# AXOD/AXODE (AX4S) UPDATE HANDBOOK

# INTRODUCTION

This updated version of the AXOD "Update Handbook" will also cover the changes that occurred in the 1991 model year, when electronic controls were adapted to the AXOD transaxle, making it an AXODE, and now called an AX4S transaxle. We have included the changes on the AX4S transaxle up through and including model year 2002.

Figure 29

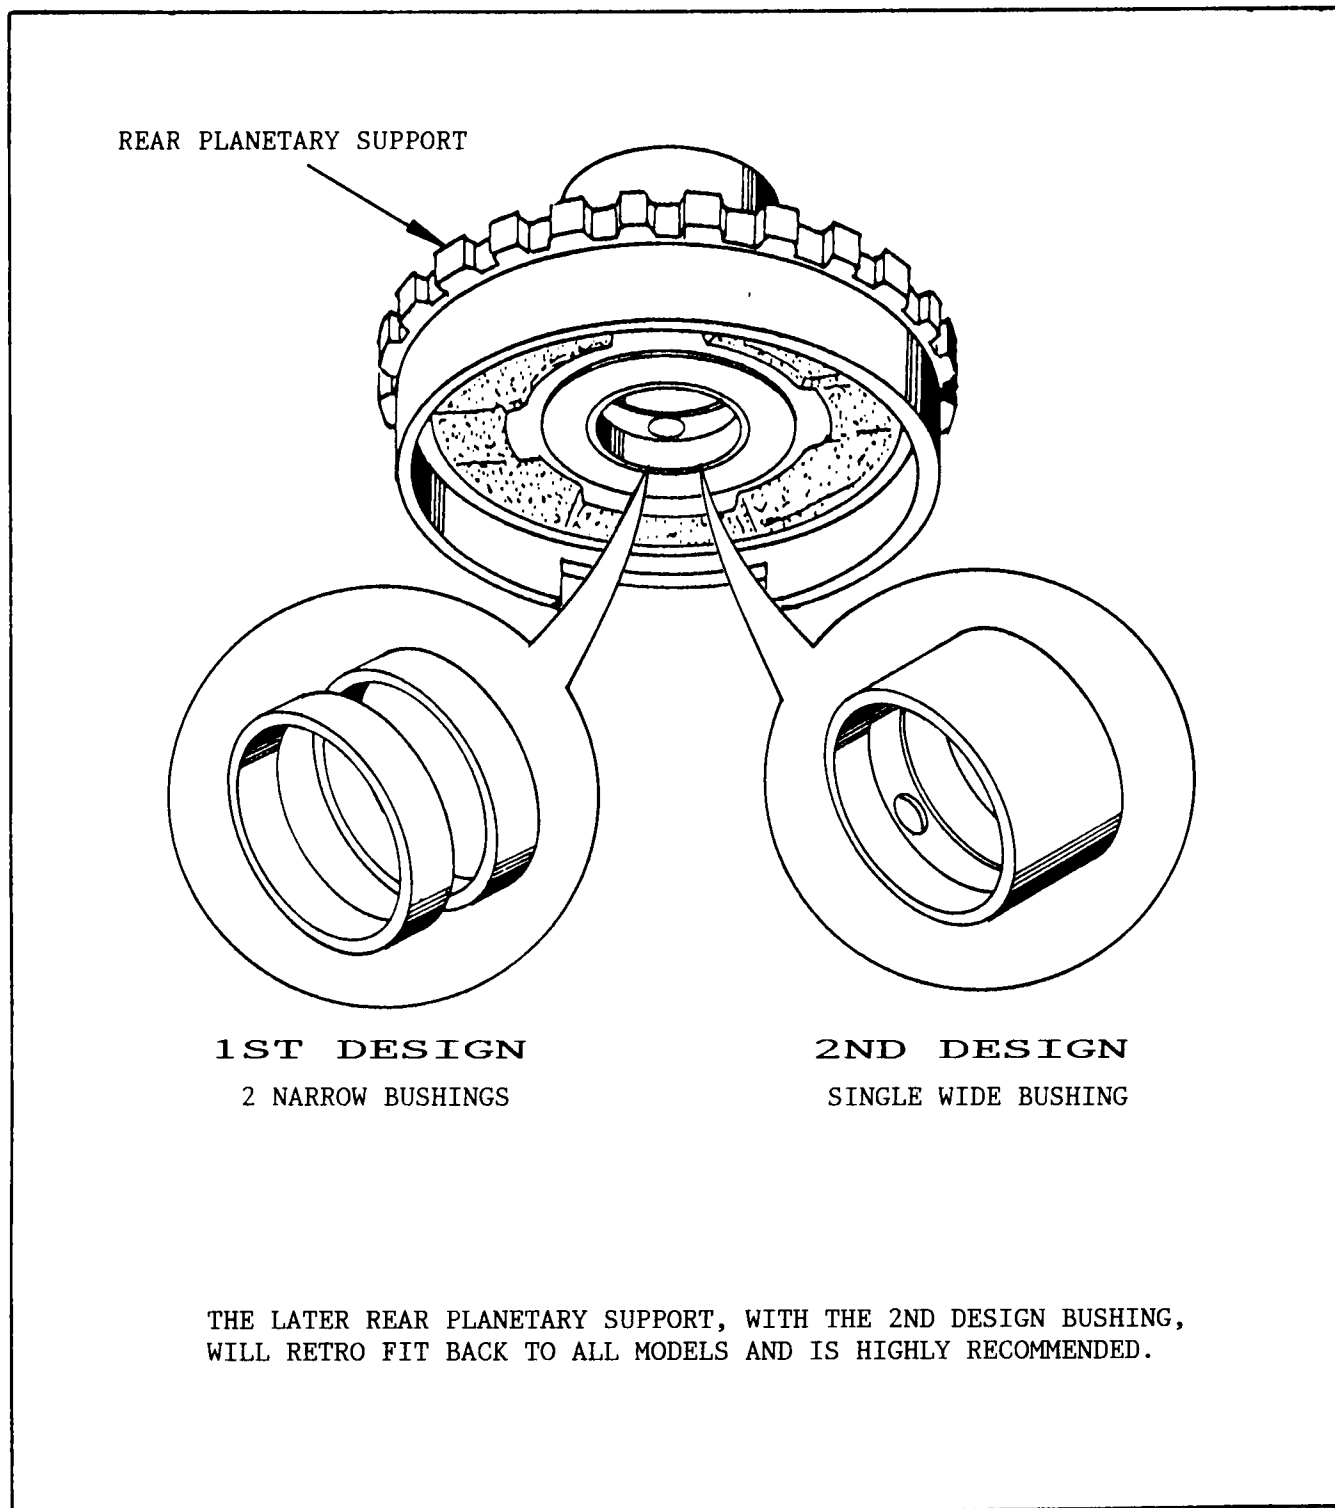
3. Inspect the bushings in the rear planetary support, as these bushings can move out of position and block the lube oil hole located in the support between them. The 1988 and later rear planetary support has a new design, wider, one piece bushing with a groove and lube hole in the center. This will provide more surface area to prevent the bushing from moving. Refer to Figure 29.

The later rear planetary support, with the 2nd design bushing, will retro fit back to ALL previous models and is highly recommended. The new design rear planetary support is available under OEM part number E6DZ-7A130-A.

Figure 32

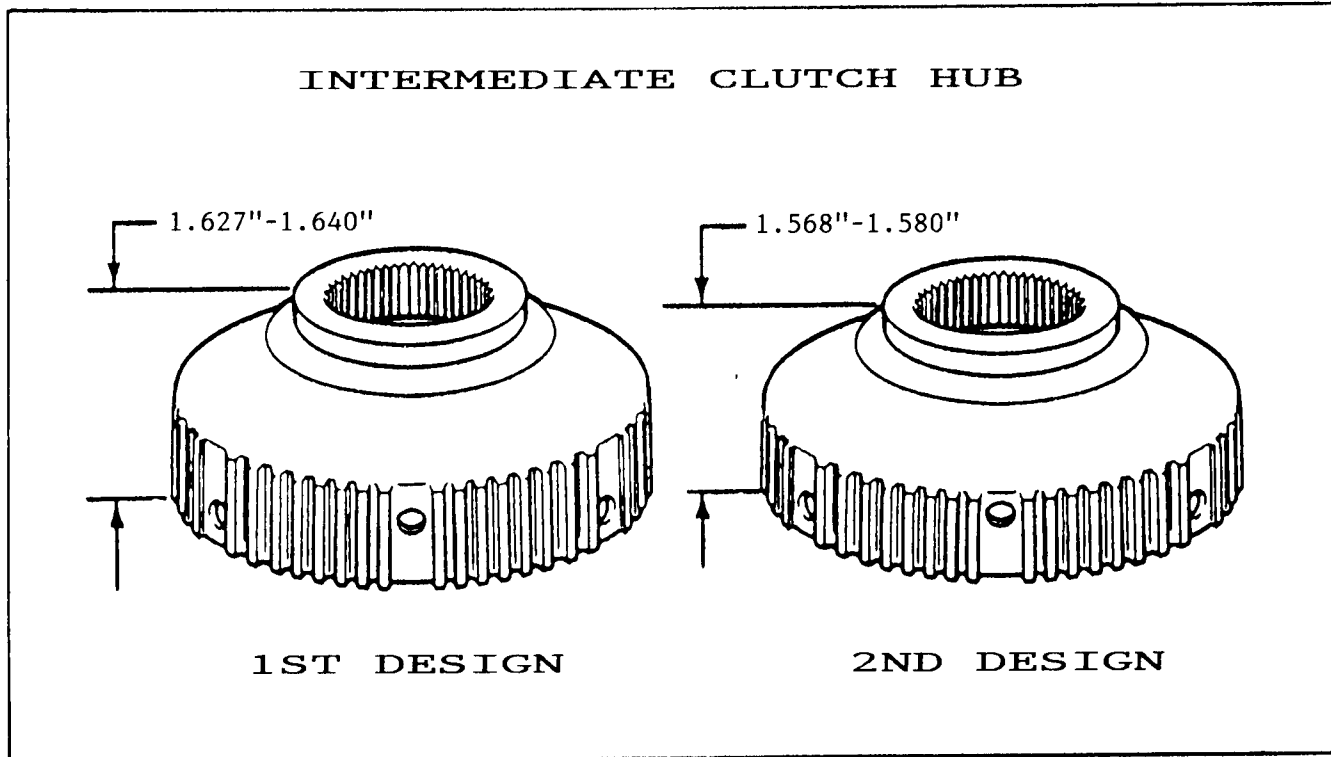
- (2) **INTERMEDIATE CLUTCH HUB** - Overall height was made shorter by approximately .060" with no identifying marks. The hub **MUST** be measured with a dial caliper or depth gage.  
The 1st design hub will measure 1.627"-1.640", and the 2nd design hub will measure 1.568"-1.580" as shown in Figure 32.

Figure 35

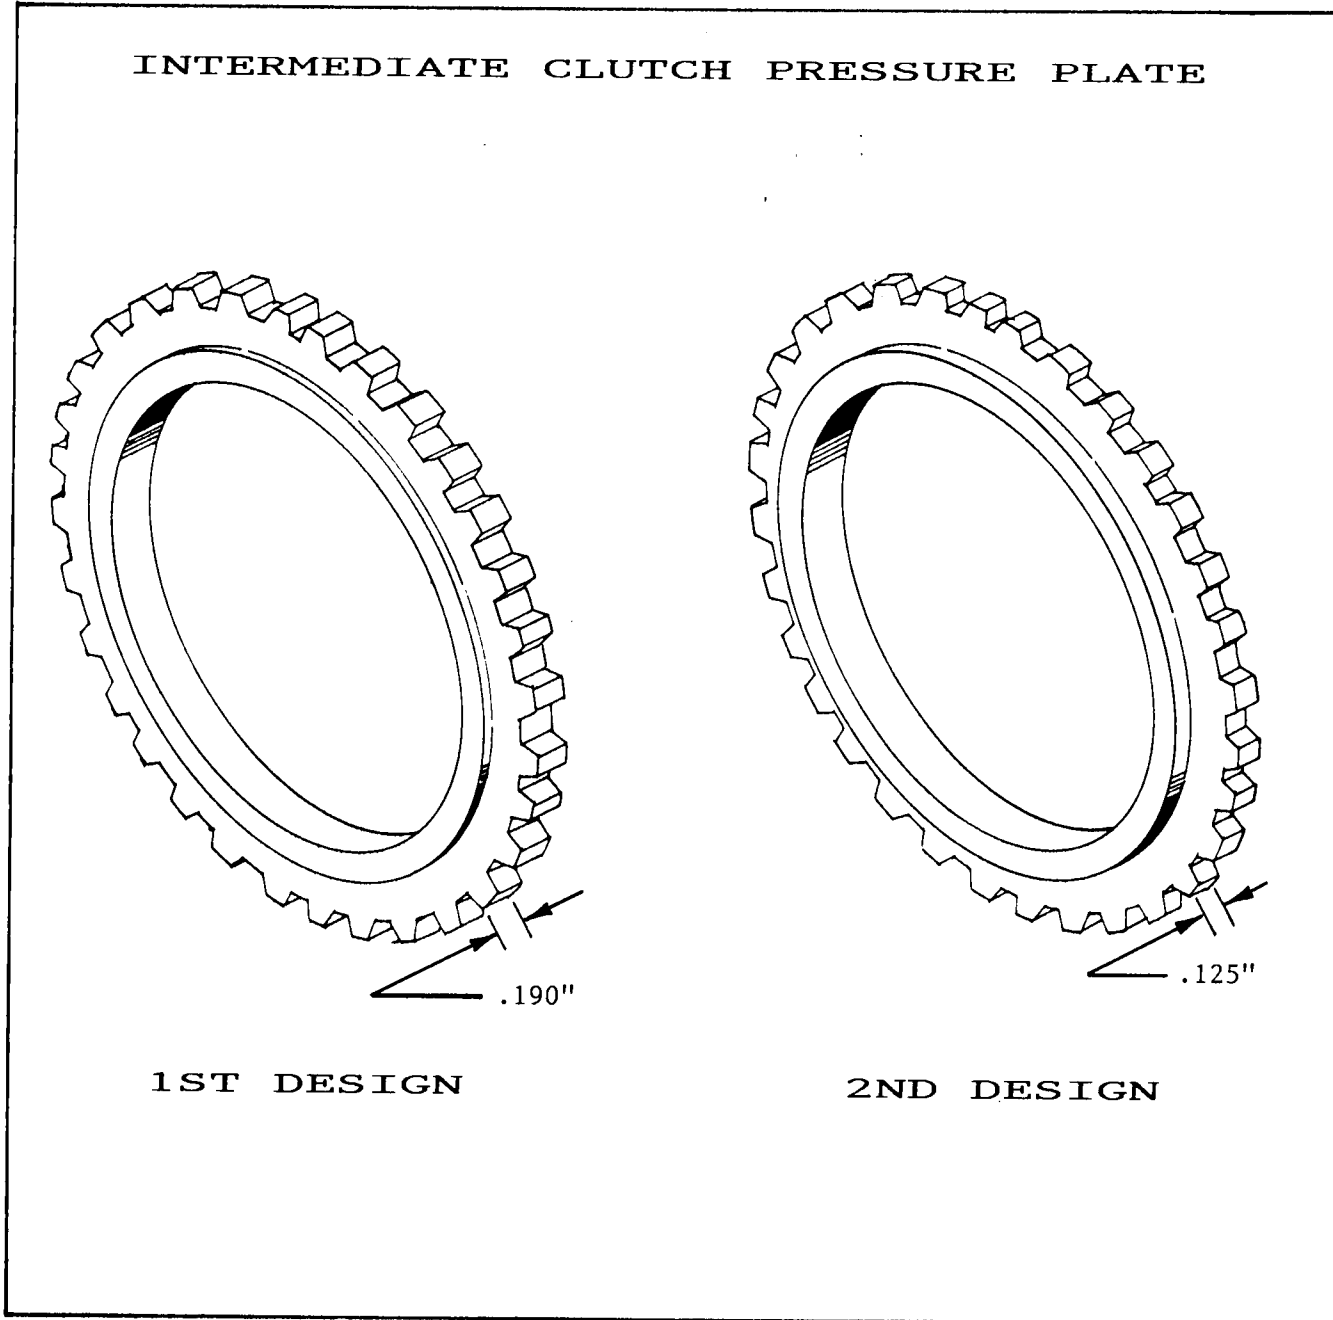
- (4) **INTERMEDIATE CLUTCH PRESSURE PLATE** - Thickness was reduced by .065" to help accommodate the added wave plate on 3.8L models, or the added spacer plate on 3.0L models.  
The 1st design pressure plate is .190" thick, and the 2nd design pressure plate is .125" thick as shown in Figure 35.

Figure 37

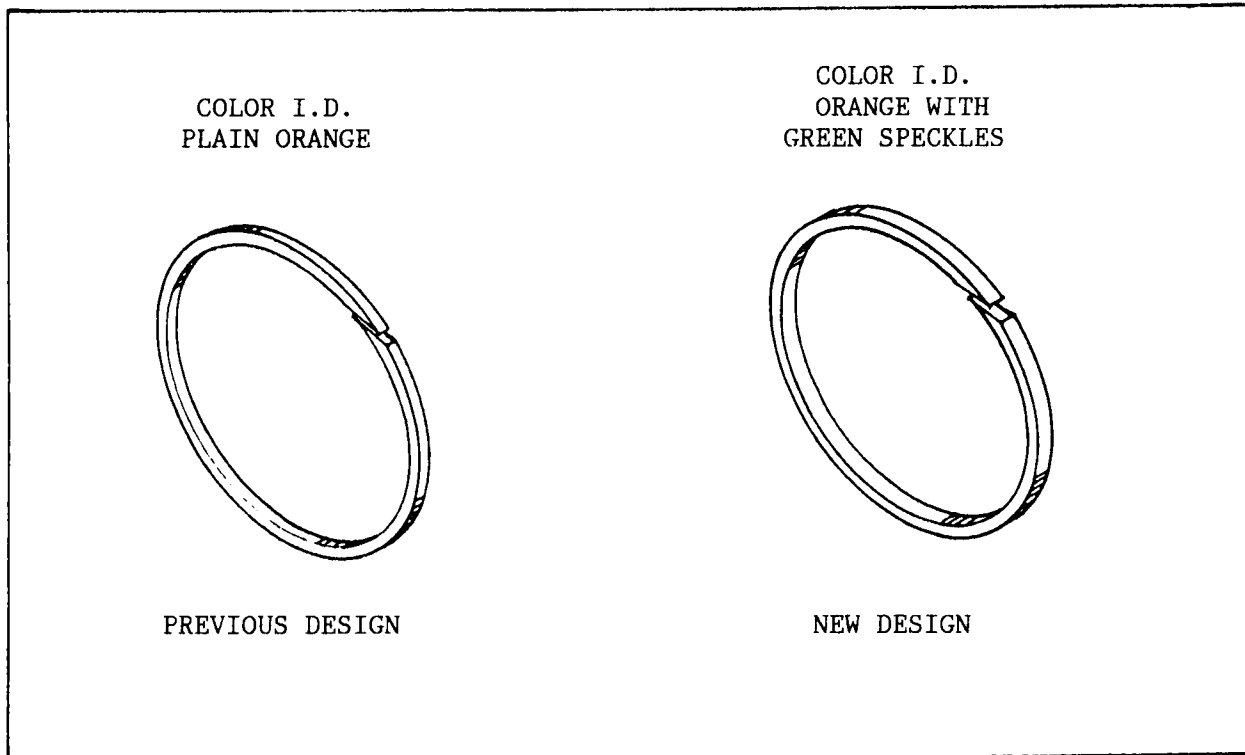
The five sealing rings on the driven sprocket support have been re-designed to help eliminate leakage in this area. The width of the sealing rings has been increased by approximately .015", and the new color identification is orange with green speckles (See Figure 37). The previous design sealing rings were plain orange in color.

The new design sealing rings are available under OEM number E6DZ-7D019-A, and should be used on ALL previous model AXOD transaxles.

Figure 38

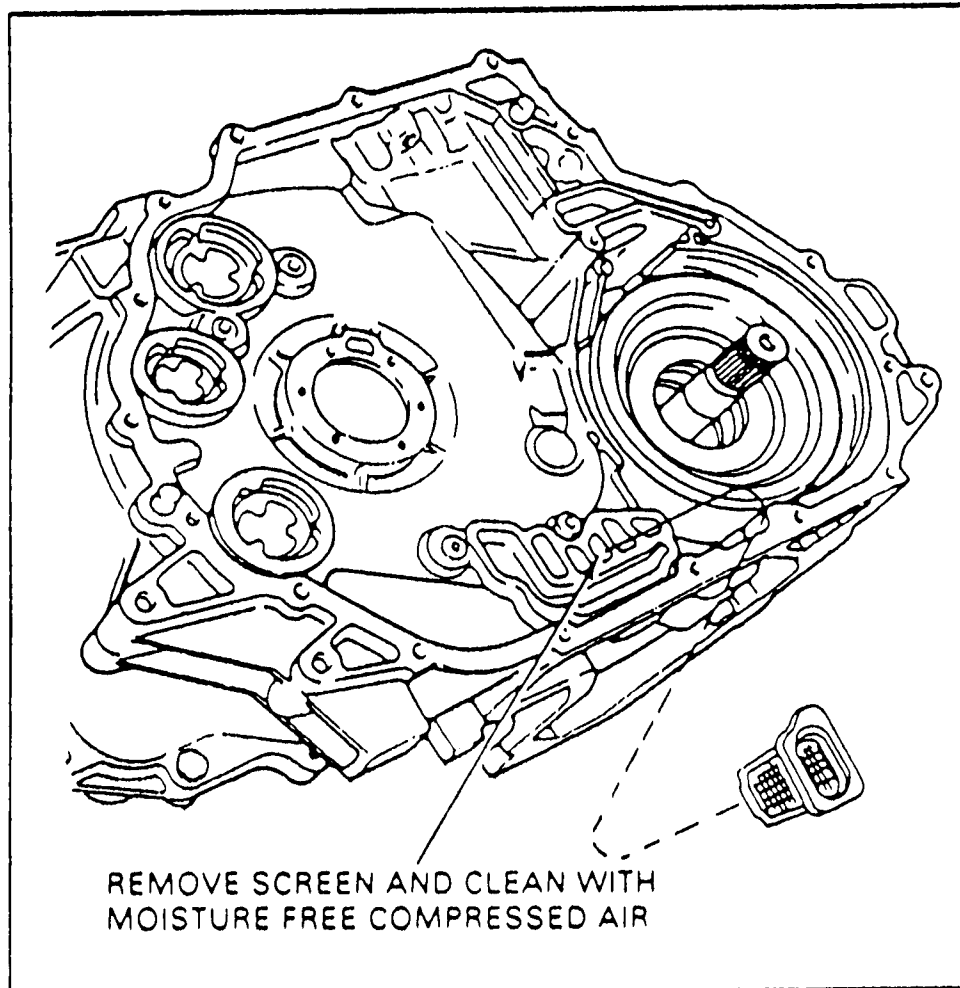
CHANGE: A new filter has been added to the 1989 AXOD 1-2 servo apply circuit as shown in Figure 38.

Figure 40

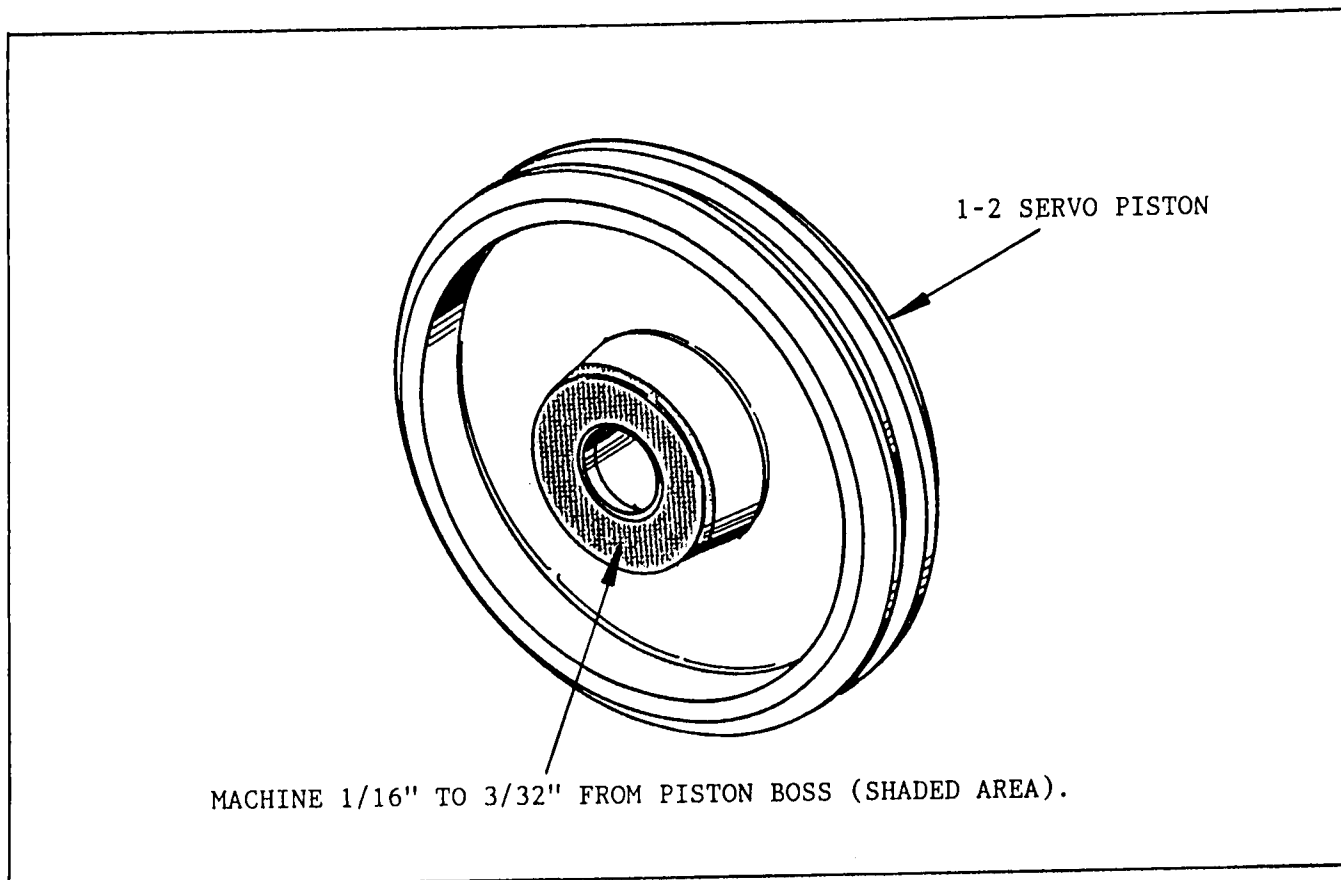
CAUSE: Insufficient travel of the 1-2 piston against the cushion spring.

CORRECTION: Remove  $1/16''$  to  $3/32''$  from the boss on the inside of the 1-2 servo piston as shown in Figure 40. We have shaded the area to be machined (See Figure 40).

Figure 41

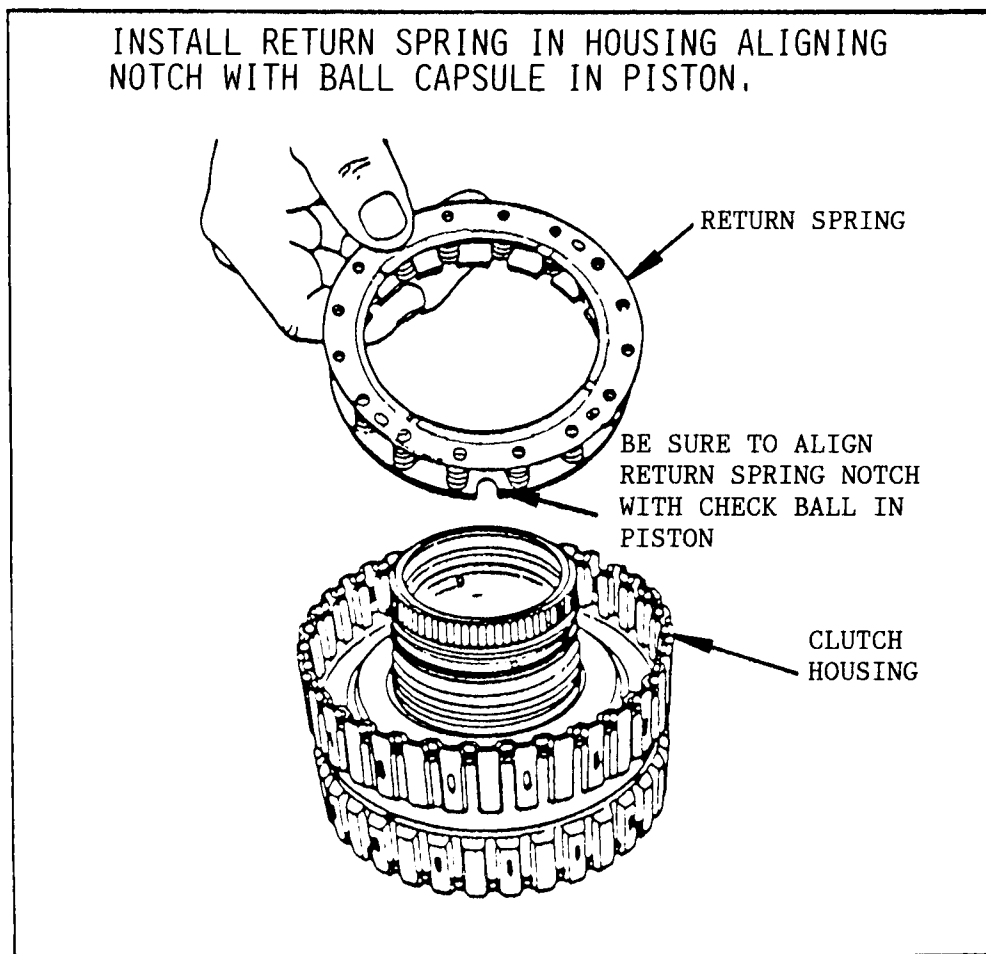
**CORRECTION:** Special care must be taken during the overhaul operation when re-assembling the direct clutch return spring over the direct clutch piston. Make sure that the notch in the spring bottom retainer (See Figure 41) is positioned properly over the check ball capsule so as not to block or restrict oil flow of the check ball assembly. Refer to Figure 41.

Figure 43

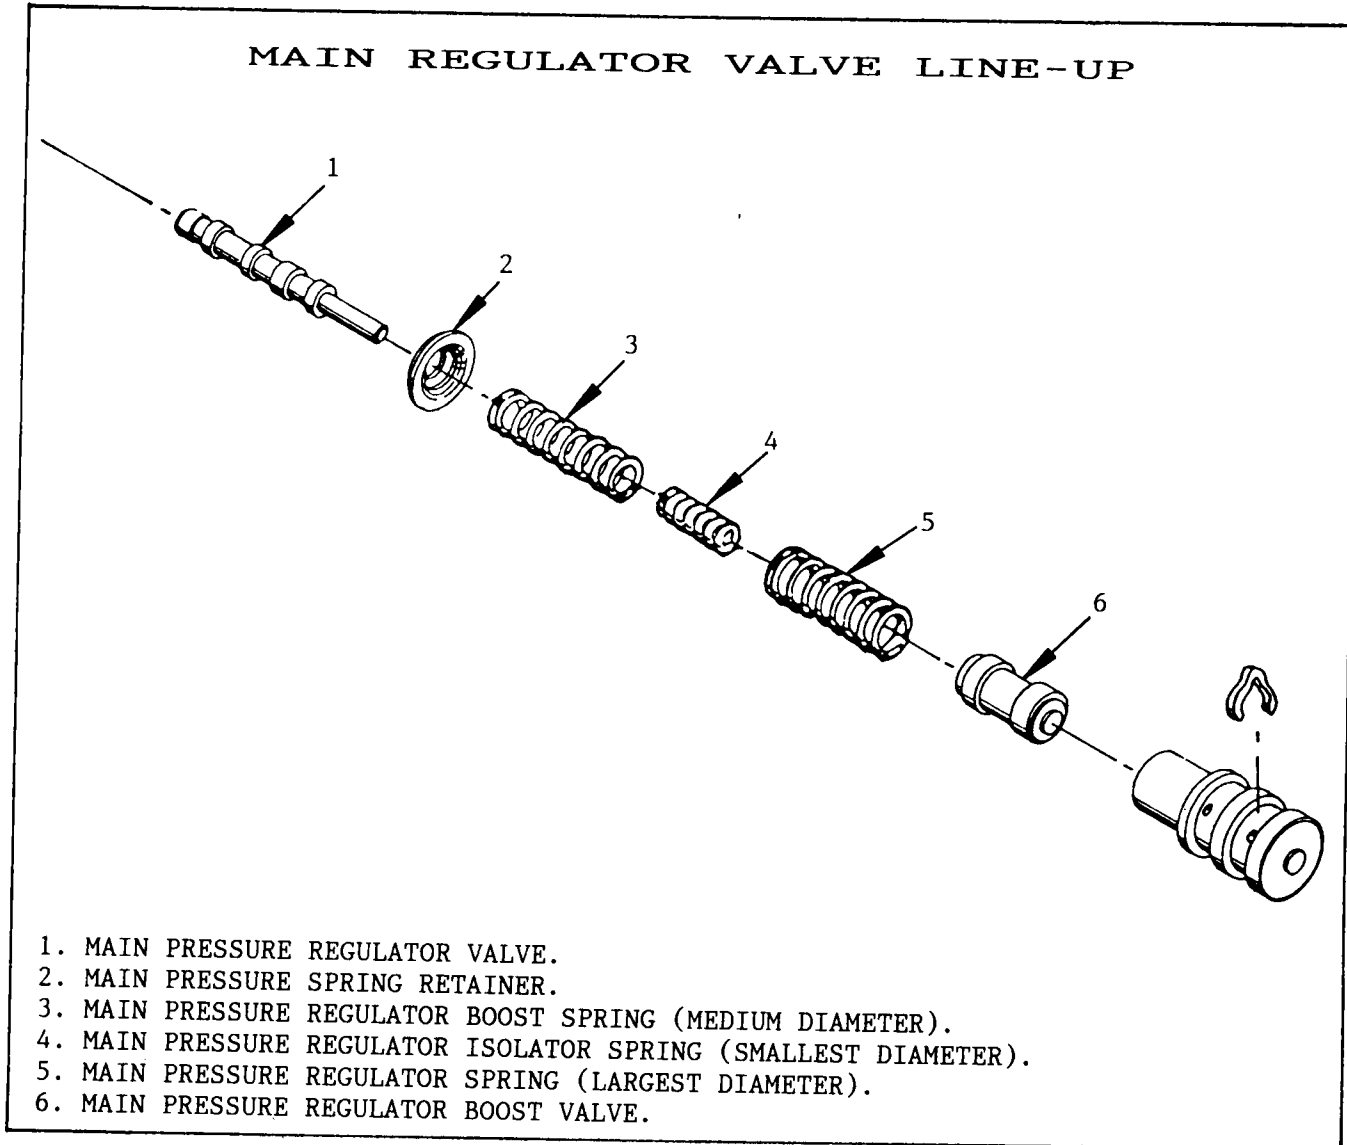
- CAUSE:
- NO. 1. A "Shudder" during a 1-2 upshift will occur if the main pressure regulator "Isolator" spring is not installed after cleaning the valve body (See Figure 43). This is caused by fluctuations in main line pressure at the time of the 1-2 shift.
  - NO. 2. Delayed upshifts can be caused by the pressure regulator spring retainer being installed backwards (See Figure 43). This will create low main line pressure.

- CORRECTION:
- NO. 1. Insure that all three (3) pressure regulator springs are re-installed in the valve body regulator bore (See Figure 43).
    - 1. Main Pressure Regulator Spring (Largest Diameter).
    - 2. Main Regulator Boost Spring (Medium Diameter).
    - 3. Main Regulator Isolator Spring (Smallest Diameter).
  - NO. 2. Insure that the main regulator spring retainer is installed in the proper direction (See Figure 43). The retainer is very similar to the one used in the AOD valve body, but is installed in the opposite direction of the AOD (See Figure 43).
